Technical Service Bulletin: tsb101326

New Single Box Breather Assembly

Figure 1.

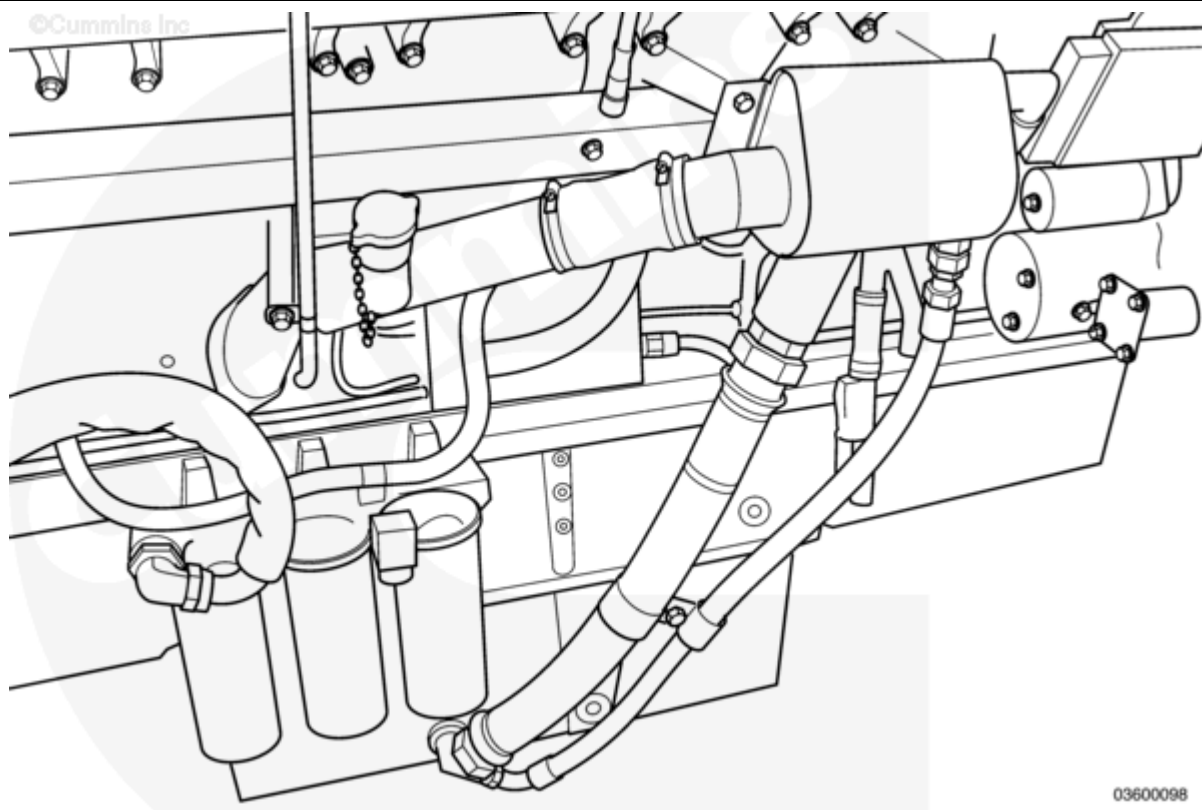
This service/parts topic introduces a new crankcase breather system for the QSK45 and QSK60 series engines. This design replaces the conventional head deck and crankcase side mounted breather arrangement in order to alleviate oil carryover which the conventional head deck and crankcase side mounted breather system exhibits.

Figure 1. shows the new design fitted to a QSK60 series engine (QSK45 series engines are similar).
